Access Compliance Report Public Rights-of-Way (Pedestrian Signals)

Main Street: **ST_CLOUD_DR** Cross Street: **SEAL_BEACH_BLVD** Location: **SE**

ADA ID: **SGRK211206160016** Signal Type: **One Push Button-Non APS** Overall Compliance: **No** Severity Scores: **BTN 1: 10** **BTN 2: N/A** **No BTN: N/A**

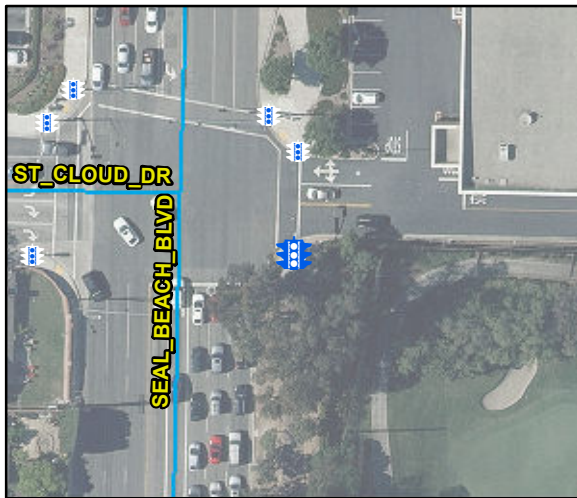
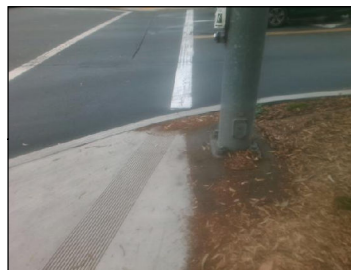
N/A Is Button 1 APS or Non-APS?	NonAPS	N/A Is Button 2 APS or Non-APS?	N/A
N/A B 1 VibroTact Arrow?	N/A	N/A B 2 VibroTact Arrow?	N/A
N/A B 1 VibroTact Parallel to Xing?	N/A	N/A B 2 VibroTact Parallel to Xing?	N/A
N/A B 1 VibroTact Contrast	N/A	N/A B 2 VibroTact Contrast	N/A
No B 1 Pilot Light?	No	N/A B 2 Pilot Light?	N/A
N/A B 1 Pilot Light Illumination?	N/A	N/A B 2 Pilot Light Illumination?	N/A
N/A B 1 Walk Indicator Type	N/A	N/A B 2 Walk Indicator Type	N/A
N/A B 1 Walk Indicator Audible?	N/A	N/A B 2 Walk Indicator Audible?	N/A
N/A B 1 Locator Tone?	N/A	N/A B 2 Locator Tone?	N/A
N/A B 1 Tone Audible Range?	N/A	N/A B 2 Tone Audible Range?	N/A
B 1 Addl APS Features?	No	B 2 Addl APS Features?	N/A
B 1 Addl APS Features Notes	N/A	B 2 Addl APS Features Notes	N/A

Possible Solutions: Replace Signal Push Button With APS Button.
